# Access Compliance Report

## Public Rights-of-Way

Intersection ID: N/A	Main Street: SHARON RD	Cross Street: HAZELTON DR	Location: NW
ADA ID: C0B9DB1911D7	Ramp Type: Perp	Initial Pass/Fail: Fail	Overall Compliance: No
Severity Score: 13.75			
Codes/Mitigation Info/Possible Solution		Field Measurements/Component Compliance

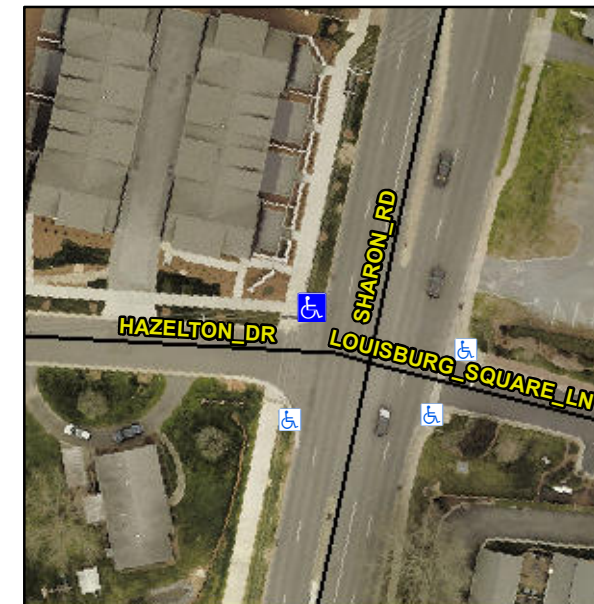
**R304.2.2, R304.5.3**

Compliance	Description	Data	Compliance	Description	Data
N/A	Ramp Length (in)	40.0	No	Ramp Slope (%)	11.9
Yes	Ramp Width (in)	120.0	No	Ramp XSlope (%)	3.2
N/A	Flare Type LT	N/A	N/A	Flare Type RT	N/A
N/A	Flare Slope LT (%)	N/A	N/A	Flare Slope RT (%)	N/A
N/A	Flare Traversable LT?	No	N/A	Flare Traversable RT?	No
N/A	Landing Length (in)	N/A	N/A	DWS Provided?	N/A
N/A	Landing Width (in)	N/A	N/A	DWS Contrast?	N/A
N/A	Landing Slope (%)	N/A	N/A	DWS Length (in)	N/A
N/A	Landing X Slope (%)	N/A	N/A	DWS Full Width?	N/A
N/A	Landing Curb? (Y/N)	N/A	N/A	DWS Offset (in)	N/A
N/A	Shared Landing?	N/A			
N/A	Gutter Ponding?	N/A	N/A	Gutter Slope (%)	N/A
N/A	Gutter Lip Ht (in)	N/A	N/A	Gutter X Slope (%)	N/A
N/A	Painted X Walk1?	No	N/A	Painted X Walk2?	N/A
	X Walk 1 Direction	To S		X Walk 2 Direction	N/A
N/A	X Walk 1 Width (in)	N/A	N/A	X Walk 2 Width (in)	N/A
	X Walk 1 Slope (%)	3.1		X Walk 2 Slope (%)	N/A
	X Walk 1 X Slope (%)	4.1		X Walk 2 X Slope (%)	N/A

**Remove & Replace Entire Ramp.**
